**Re: Tri-County Regional Vocational Technical High School
147 Pond Street
MassDEP File No. 159-1291
Notice of Intent Peer Review 3**

BETA Group, Inc. (BETA) has reviewed revised documents and plans for the ***Tri-County High School development***, located at ***147 Pond Street*** in Franklin, Massachusetts. This letter is provided to update BETA's findings, comments and recommendations.

"B-series" Wetland Overflow in Existing (left) and Proposed (right) at the 100-year Storm Event

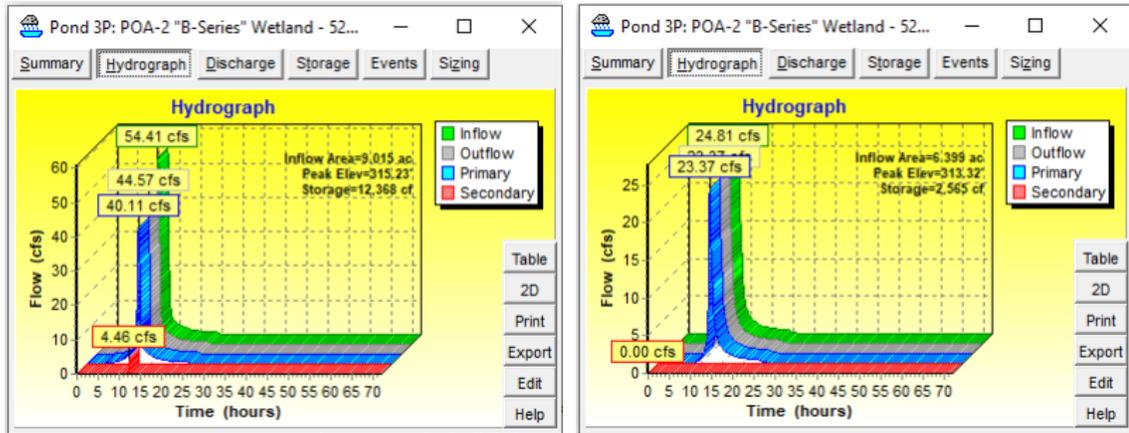
SW16. Provide comparison of pre- and post-development runoff volume. Post-development runoff volume shall not exceed pre-development volumes from the Site (§300-11.A(3)).

BETA2: The provided tables show an increase in runoff volume to POA1, POA-2, POA-3, and POA-7. These points of analysis represent the "A" and "B" Series wetlands as well as the two Tri-County Drive closed drainage systems. The HydroCAD model has been revised to model the "A" and "B" series wetlands as ponds which serve to demonstrate how these low-lying areas will be impacted by the increased runoff volume. Both wetlands are shown to flood under both existing and proposed conditions, but flooding is increased under post-development conditions resulting in greater overland flow onto Tri-County Drive. Excess stormwater will be directed to the Tri-County Drive system.

An increase in volume in the post-development condition at POA-1, POA-3 and POA-7 is unavoidable due to site constraints, including soils with very limited infiltration capacity. By adjusting the Stormwater Management design by connecting the discharge from BMP-4 to the 36" RCP located within/adjacent to Tri-County School Drive rather than directing flow to the B-Series Wetland, the post-development runoff volume to this wetland system will be maintained below pre-development values.

As previously discussed, the storage volume provided in the stormwater management design will flatten the peak rates of runoff at POA-1 and POA-3 for the 2-, 10-, 25- and 100-year storm events. Thus, more volume will pass through these points of analysis over a longer period of time, but at lower peak rates. In addition, by directing flow from BMP-4 away from the B-Series Wetland, the model shows that stormwater will no longer overtop the B-Series Wetland to the A-Series Wetland during the 100-year storm event. This will, in turn, reduce the amount of stormwater that overtops the A-Series Wetland to POA-7 in the 100-year event, mitigating the post-development peak rate of runoff to be less than pre-development conditions for this storm event. Through conversations with the Commission, it has been confirmed there have been no reports historically from the School and Town about flooding issues in these on-site or downgradient areas. Therefore, it is reasonable to infer that the slight increases in rate for the 2-, 10-, and 25-year storm events directed to POA-7 can be managed by the existing drainage systems within Tri-County Drive and Old West Central Street. The newly paved and curbed access drive is estimated to add an additional 2.2 cfs to the existing drainage system for the 25-year design storm per the rational calculations. It should be noted that the access drive is being upgraded to 20 feet wide to meet National Fire Protection Association (NFPA) standards. The current gravel drive has a much smaller width and does not meet current standards.

BETA3: Information provided. BETA defers to the DPW to grant relief from §300-11.A(3) for the proposed increase in runoff volume to the offsite discharge locations at Old West Central Street and the westerly system that runs beneath Hilltop Drive. BETA also defers to the DPW to confirm the increased flow rate to Old West Central Street (2.2 cfs for the 10-year storm event) is acceptable. BETA notes that peak flows directed to wetlands in the project area have been mitigated to meet MassDEP requirements.

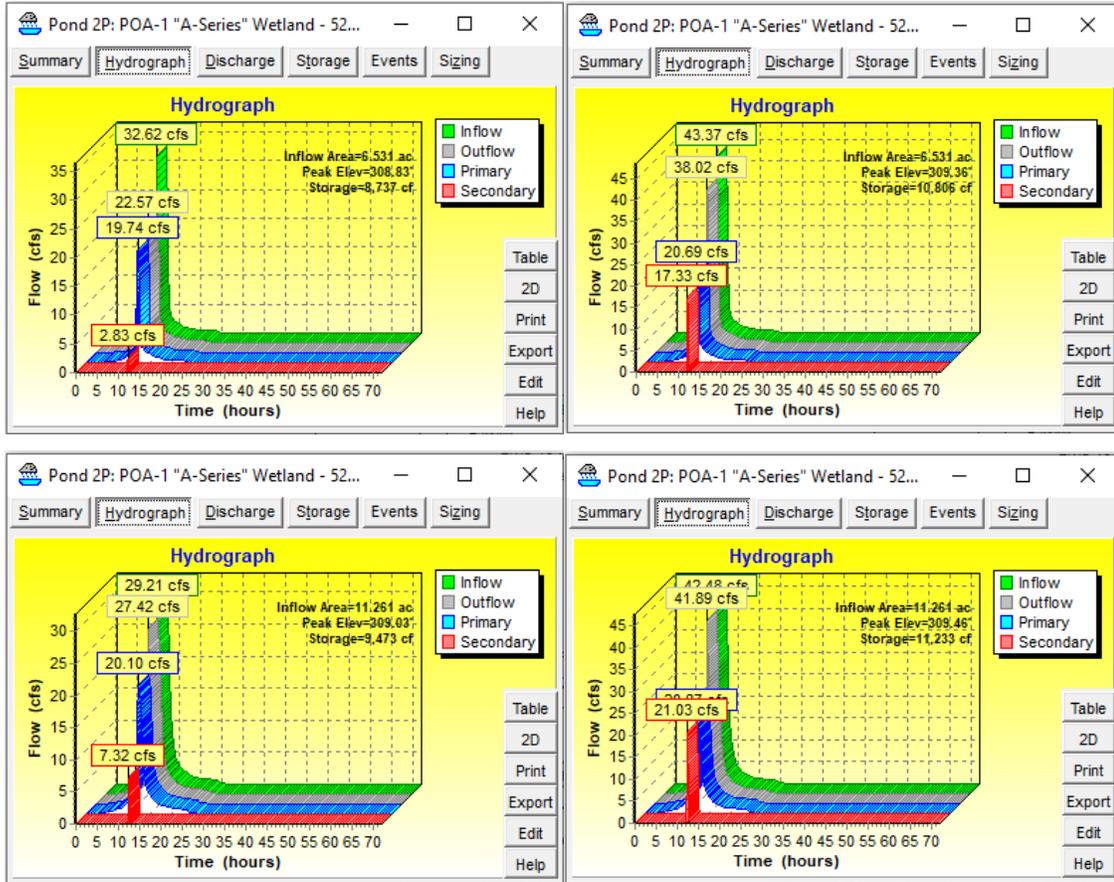
SW31. Provide table comparing pre- and post-development runoff volumes for each watershed area to evaluate flooding impacts to wetland resource areas and downgradient properties.

SCI: Refer to Response to Comment SW16 for table comparing pre- and post-development runoff volumes for each watershed area. To evaluate the impacts for increasing volumes to the "A-series" and "B-series" wetlands, the wetlands were included as Ponds in both the existing and proposed HydroCAD models. Given the surface contours and volume available at each wetland, the model shows some overtopping at the "A-series" wetland in the existing condition at the 25- and 100-year storm events. Reviewing existing topography, theoretical runoff that overflows from the "A-series" wetland appears to run down the vegetated slope alongside Tri-County Drive to the inlet upgradient from the existing access drive. Any flows that do not get captured by the inlet appears to be directed on to Tri-County Drive or continue down and alongside Tri-County Drive. In the proposed condition, it appears that runoff will overtop the "A-series" wetland also during the 25- and 100-year storm events, but to a greater degree than existing. "A-series" Wetland Overflow in Existing (top) and Proposed (bottom) at 25-year (left) and 100-year (right) Storm Events
